RENESAS TECHNICAL UPDATE

Product Category	MPU/MCU		Document No.	TN-RZ*-A0110A/E	Rev.	1.00
Title	RZ/G2H, RZ/G2M V1.3, RZ/G2M V3.0 and RZ/G2N specification change the accuracy of Thermal Sensor Characteristics		Information Category	Technical Notification		
Applicable Product	RZ/G Series, 2nd Generation RZ/G2H RZ/G2M V1.3, V3.0 RZ/G2N	Lot No.		RZ/G Series, 2nd Generation User's Manual: Hardware Rev.1.11 (R01UH0808EJ0111)		
		All lots	Reference Document

Specification change from Tj to Tjs due to thermal sensor(THS) issue

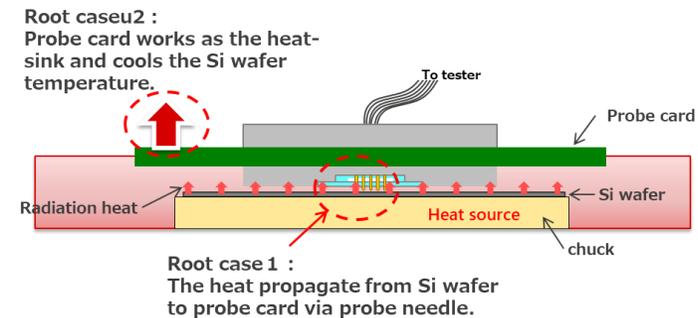
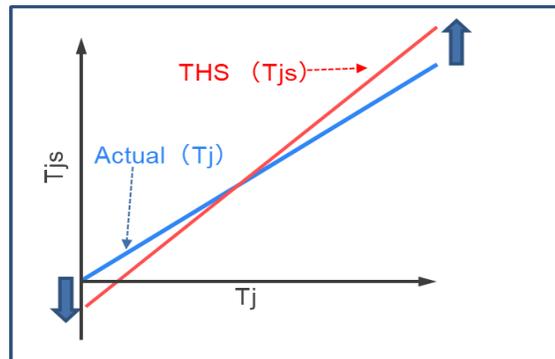
Junction temperature which shows thermal sensor(Tjs) will indicate higher temperature(Tj=115degC) than actual junction temperature(Tj) at high temperature, and lower temperature(Tj=-40degC) at low temperature.

The parameter of THCODE and PTAT which are used in Tjs calculation were affected test temperature shift due to heatsink effect by probe card in mass production test. The test temperature in high temperature test is cooled than set temperature at test. And the test temperature in low temperature test is warmed up than set temperature at test.

However, Tjs calculation formular is made to be based on set temperature at test. As the result, thermal sensor shows faulty behavior.

Root caseu2 :
Probe card works as the heat-sink and cools the Si wafer temperature.

Root case 1 :
The heat propagate from Si wafer to probe card via probe needle.

■Limitation
　Junction temperature which shows thermal sensor(Tjs) will indicate higher temperature than actual junction temperature(Tj) at high temperature, and lower temperature at low temperature.
